CONSTRUCTION SUMMARY				
Palmetto - Zadorra Estates Corp.				TEL:
PURCHASERS: Ali AHMED and Shams Us SABAH				
LOT / PHASE	REG. PLAN #	HOUSE TYPE		
36 / 1		Villa 2 Elev 3

Villa 2 36' LOT

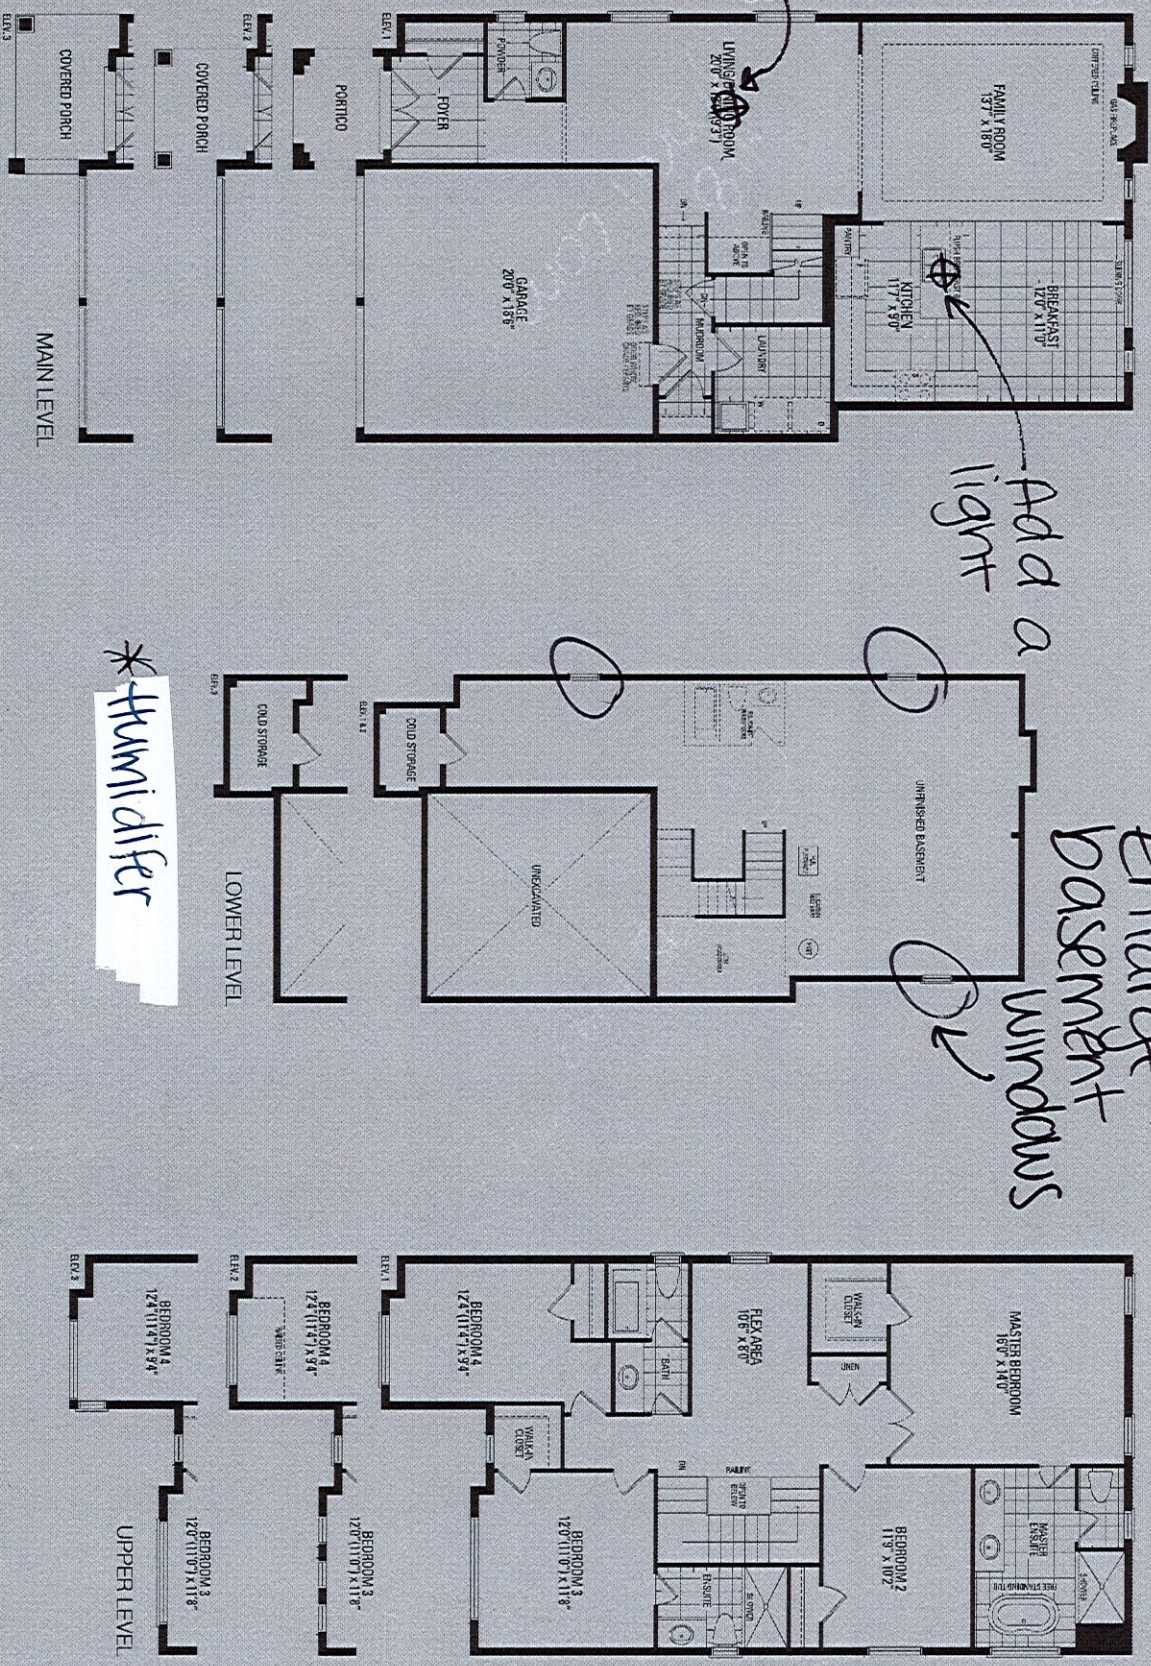
std. dining
rm light to
be centered

Add a
light

Enlarge
basement
windows

*Humidifier

10' ceiling on first floor

1 - FIRST FLOOR INCREASE CEILING HEIGHT FROM 9 FEET TO 10 FEET 13Jul23 Note:	
3 - ENLARGED BASEMENT WINDOWS (MAY REQUIRE WINDOW WELLS) - WINDOW IS 30 INCHES X 24 INCHES 12Jul23 Note:

1 - ABOVE KITCHEN ISLAND - ADD LIGHT AND SWITCH - NO FIXTURE INCLUDED 22Sep23 Note:	
1 - STANDARD DINING ROOM LIGHT TO BE CENTERED BETWEEN LIVING AND DINING ROOM 22Sep23 Note:

1 - HUMIDIFER 22Sep23 Note:	
-----------------------------------	--
